State of New Mexico
Energy, Minerals and Natural Resources

WELL API NO.	30-025-01963
5. Indicate Type of Lease	STATE <input checked="" type="checkbox"/> FEE <input type="checkbox"/>
6. Oil & Gas Lease No.	B1520
7. Lease Name or Unit Agreement Name	BRIDGES STATE
8. Well Number	086
9. OGRID Number	298299
10. Pool name or Wildcat	VAC QUEEN GAS
11. Elevation (Show whether DR, RKB, RT, GR, etc.)	4056 GR

SUNDRY NOTICES AND REPORTS ON WELLS
(DO NOT USE THIS FORM FOR PROPOSALS TO DRILL OR TO DEEPEN OR PLUG BACK TO A DIFFERENT RESERVOIR. USE "APPLICATION FOR PERMIT" (FORM C-101) FOR SUCH PROPOSALS.)

Proposed P&A

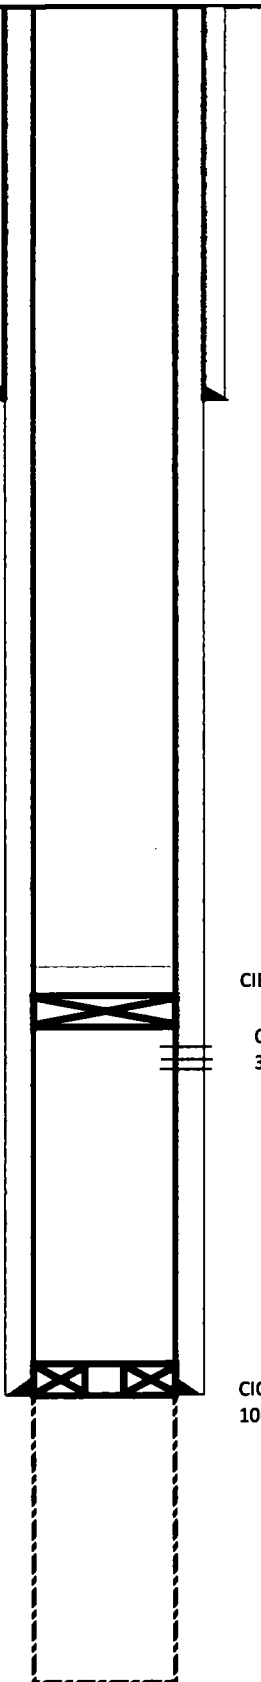
1. MIRU. TIH to tag cement on top of CIBP at an estimated 3,840'. Pressure test casing to 500 psi for 15 minutes. Circulate hole w/ mud laden fluid.
2. Plug #1: Spot ²⁵ 12 1/2" Class G Cement on top of current plug from 3,840' - 3,770'.
3. Plug #2: Spot ²⁵ 12 1/2" Class G Cement from 2,780' - 2,680'. WOC. Tag TOC.
4. Plug #3: Spot ²⁵ 12 1/2" Class G Cement from 1,710' - 1,610'.
5. Plug #4: Spot ²⁵ 6" Class G Cement from ²⁰⁰ 50' to surface.
7. Cut off wellhead. Verify cmt to surface on all strings. Install dry hole marker.

See Attached
Conditions of Approval
